Access Compliance Report

Public Rights-of-Way

(Curb Ramps)

Intersection ID: 44936	Main Street: REEDMONT_LN	Cross Street: ACORN_FOREST_LN	Location: E
ADA ID: A10F34EAE5C3	Ramp Type: Perp	Initial Pass/Fail: Fail	Overall Compliance: No
Severity Score: 22.5			
Codes/Mitigation Info/Possible Solution		Field Measurements/Component Compliance

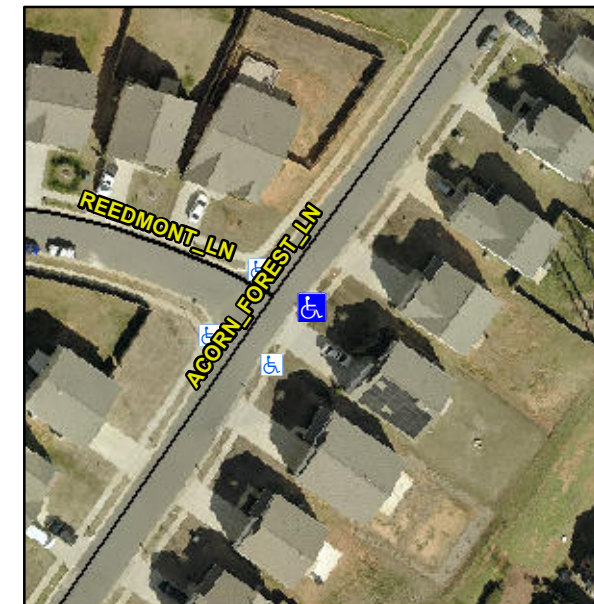
Not Found, R304.5.1, R304.2.2

Compliance	Description	Data	Compliance	Description	Data
N/A	Ramp Length (in)	47.5	No	Ramp Slope (%)	8.7
No	Ramp Width (in)	46.5	Yes	Ramp XSlope (%)	2.5
N/A	Flare Type LT	N/A	N/A	Flare Type RT	N/A
N/A	Flare Slope LT (%)	N/A	N/A	Flare Slope RT (%)	N/A
N/A	Flare Traversable LT?	N/A	N/A	Flare Traversable RT?	N/A
N/A	Landing Length (in)	N/A	N/A	DWS Provided?	N/A
N/A	Landing Width (in)	N/A	N/A	DWS Contrast?	N/A
N/A	Landing Slope (%)	N/A	N/A	DWS Length (in)	N/A
N/A	Landing X Slope (%)	N/A	N/A	DWS Full Width?	N/A
N/A	Landing Curb? (Y/N)	N/A	N/A	DWS Offset (in)	N/A
N/A	Shared Landing?	N/A			
N/A	Gutter Ponding?	N/A	N/A	Gutter Slope (%)	N/A
N/A	Gutter Lip Ht (in)	N/A	N/A	Gutter X Slope (%)	N/A
N/A	Painted X Walk1?	No	N/A	Painted X Walk2?	N/A
	X Walk 1 Direction	To NW		X Walk 2 Direction	N/A
N/A	X Walk 1 Width (in)	N/A	N/A	X Walk 2 Width (in)	N/A
	X Walk 1 Slope (%)	3.1		X Walk 2 Slope (%)	N/A
	X Walk 1 X Slope (%)	2.7		X Walk 2 X Slope (%)	N/A

Remove & Replace Entire Ramp.
